LETTER REPORT TO SCOTT ROSS, DIVISION OF WATER
RESOURCES, KANSAS DEPARTMENT OF AGRICULTURE
CONCERNING THE ANALYSIS OF DATA PERTAINING TO FILES
44,203 and 44,246

Kansas Geological Survey Open File Report 2000-58
October 2000

Re: Analysis of the data
pertaining to File Nos.
44,203 and 44,246

Figure 1

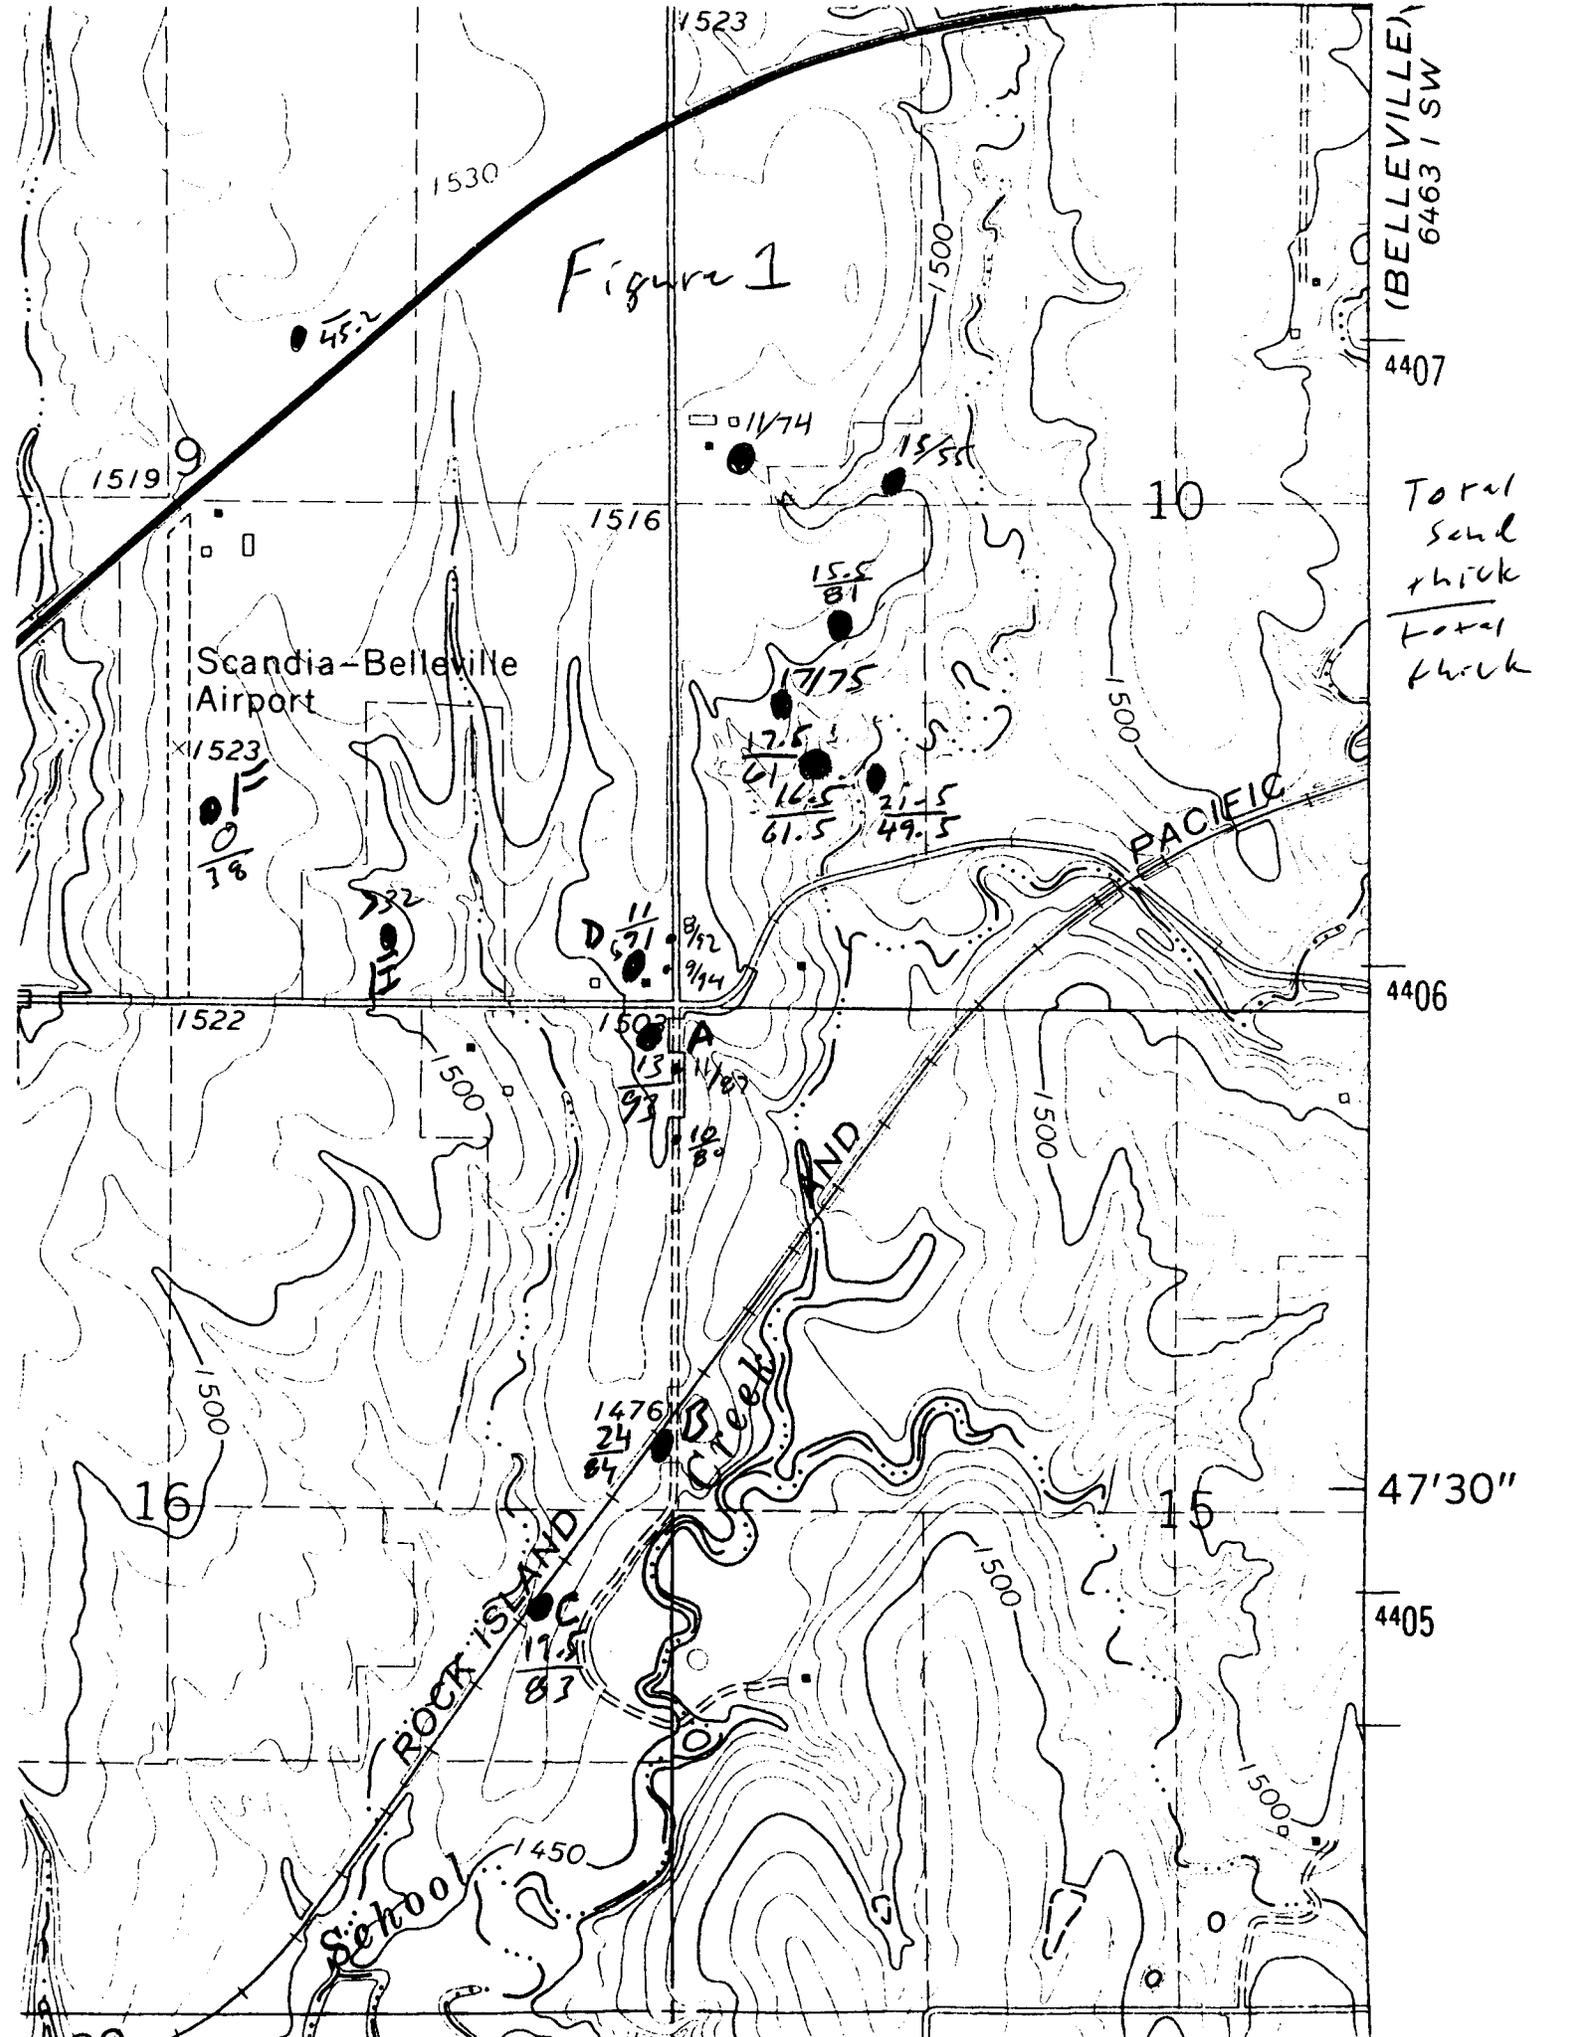
The test-hole and WWC-5 driller's logs are at odds with your aquifer extent map, our 1:500,000 scale map of Kansas Geology (M-1), and the older KGS geology and ground water resources bulletin for Republic and northern Cloud counties (Bulletin 73). The driller's logs show significant thicknesses of water-saturated sediments in the east half of the SE quarter of Section 9 and the NE quarter of Section 16. For example, the WWC-5 logs in the SESESE Section 9 and the NENENE Section 16 show that more than 90 feet of unconsolidated sediments overlie bedrock at these locations. The total thickness of sand reportedly encountered by some of these test holes is in the range of sand thicknesses reported in the logs for both Glenwood Farms and the Valley Vegetable Cooperative test holes (Figure 1). The number and distribution of logs in the eastern half of Section 9 is not sufficient to define in detail the western edge of the aquifer. However, the amount of sand encountered and the total thickness of sediments above bedrock decreases toward the center of Section 9. The log of well F, near the north-south centerline of the section in Figure

2, shows sand not being present and bedrock within 40 ft of land surface. I have concluded that the western edge of this aquifer probably coincides with the north-south drainage in the SE quarter of Section 9.

The eastern and northern extents of the aquifer cannot be defined because there are no logs of wells to the north of Glenwood Farms in the NW quarter of Section 10 and west of the tributary to School Creek in Section 10. The KGS Bulletin 73 and Map M-1 show bedrock in the stream bottom to the north. KGS Map M-1 shows loess capping the north-south ridge running through the center of Section 10, while KGS Bulletin 73 shows Carlile Shale at the surface. The nearest log is a WWC-5 record of a well drilled near the northwest corner of Section 11. To honor the worst-case scenario, I have arbitrarily defined the north and east boundaries of the aquifer as shown in the accompanying figure.

Figure 3

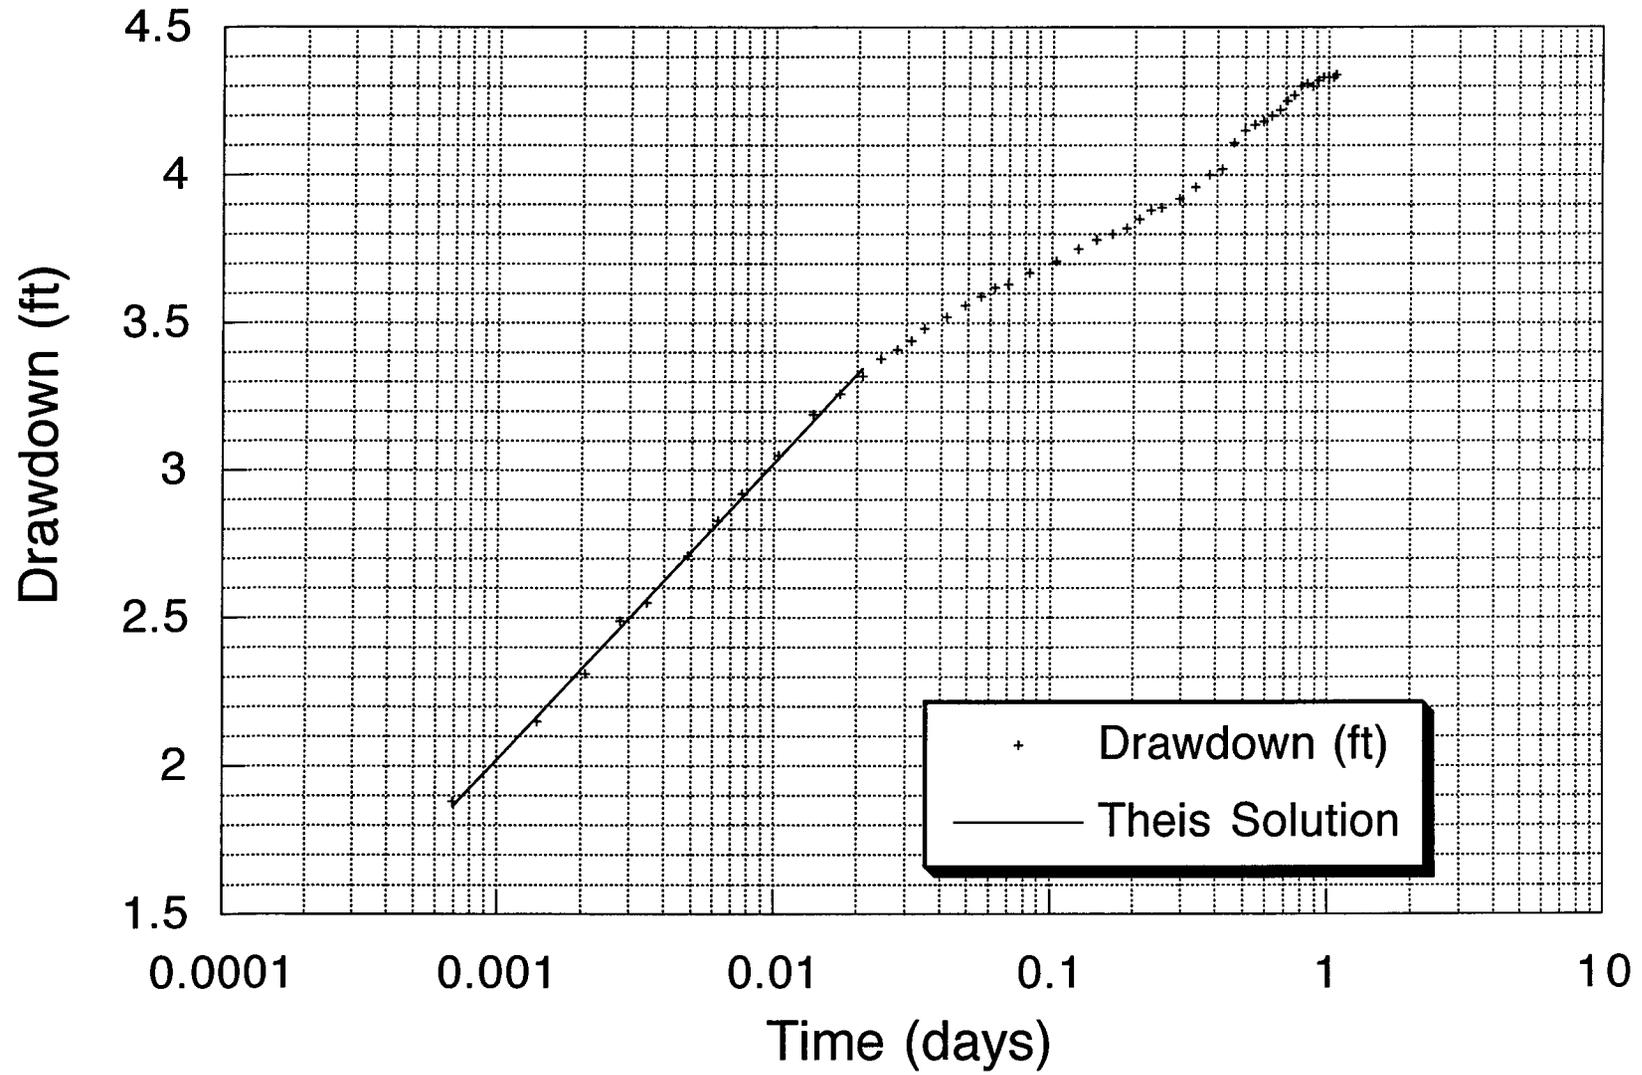
In figure 3, the plot shows the drawdown as a function of log time. The drawdown curve for the early part of the test is marked by a straight-line portion up to about 0.02 days. This straight-line segment suggests pumping under confined conditions. The aquifer property values and their associated 95% confidence limits derived from the best-fit line are a transmissivity of 3300 ± 93 ft²/day and a storativity of $3.44 \times 10^{-4} \pm 0.52 \times 10^{-4}$. The best-fit line has a low root mean square error of 0.01741 ft for the first 11 data points from the test. The transmissivity calculated from SUPRPUMP is well within the range of values estimated by Ground Water Associates from their analysis of this test, but the storativity is one order of magnitude lower.

I agree with Ground Water Associates that the drawdown curve is more consistent with the behavior of pumping from a leaky confined aquifer. This interpretation is consistent with the geology. As mentioned earlier, the driller's logs from wells and test borings indicate less than 30% sand/sand and gravel with most of these deposits near bedrock at the base of the unconsolidated sediments. In my analysis, I assumed a leaky, confined aquifer where the storage of water in the overlying aquitard does not change with time. However, water is allowed to move across the aquitard from overlying, fully-saturated sand lenses. Using the drawdown data from the first 6 hours of the test, the SUPRPUMP-derived aquifer parameters are a transmissivity of $3,242 \pm 114$ ft²/day and a storativity of $3.577 \times 10^{-4} \pm 0.66 \times 10^{-4}$. These values are identical to the aquifer properties derived from the Theis analysis of the of early time data up to about 0.02 days. The leakage coefficient is $1.104 \times 10^{-3} \pm 1.74 \times 10^{-4}$ ft². Figure 4 shows the fit of the curve to the drawdown data. The best-fit line has a low root mean square error of 0.02598 ft for the first 30 data points from the test.

Figure 4

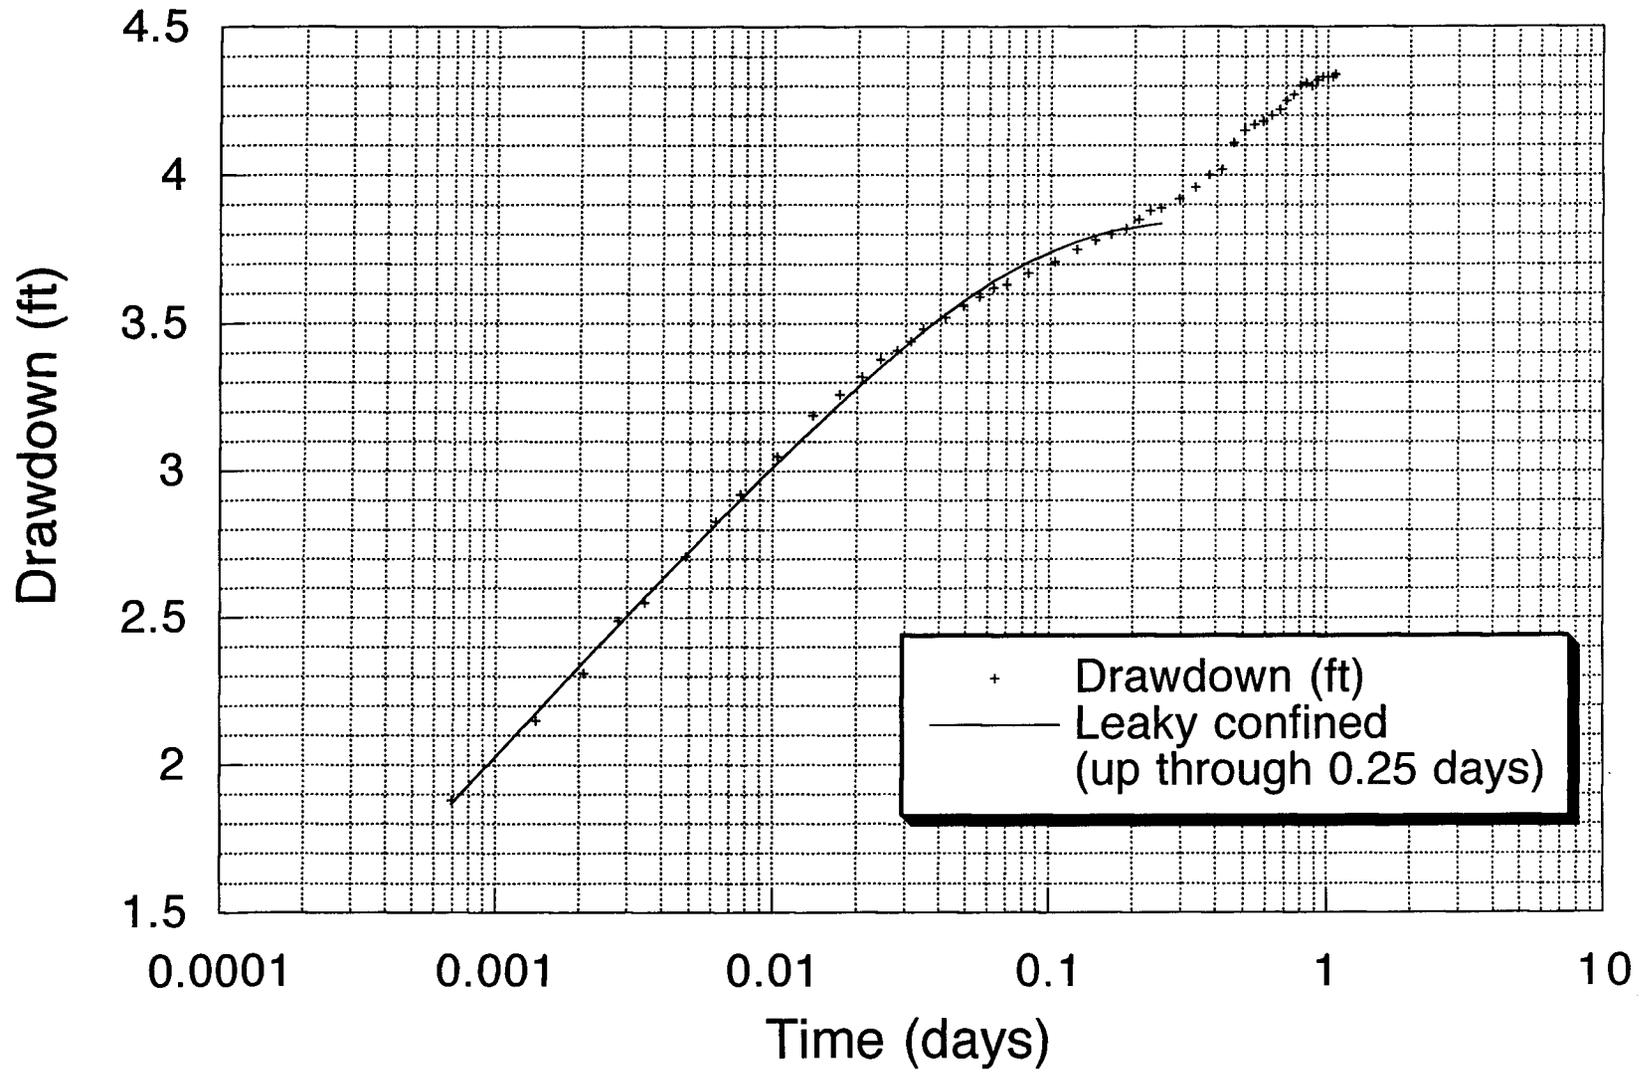
The last part of the test cannot be modeled easily with SUPRPUMP. One explanation for the drawdown after 0.25 days is that this is an unconfined aquifer and the early part of the curve is the early response of the aquifer to pumping followed by downward drainage of water, which in this case we have simulated as leakage. The later part of the curve could be interpreted as the effects of pumping after the delayed drainage has reached the water table. Near the end of the test, the curve again flattens out, suggesting that another source of recharge is beginning to supply water to the expanding cone of depression. However, there is no indication that the water table ever gets below base of the silt and clay, i.e., a change from leaky, confined to unconfined conditions. Unfortunately the pumping test was not long enough to definitely resolve this issue.

Another explanation for the later time behavior of the drawdown curve is that the staircase appearance of the drawdown curve reflects the progressive drainage of water from overlying sand lenses as the cone of depression expands. Thus, the later time behavior is explained as a reduction of leakage as sand lenses nearer the pumping are drained followed by draining of more distant sand lenses as the cone of depression continues to expand through time. The leakage to the aquifer is episodic as the test continues which results in a variable rate of drawdown increase over time.
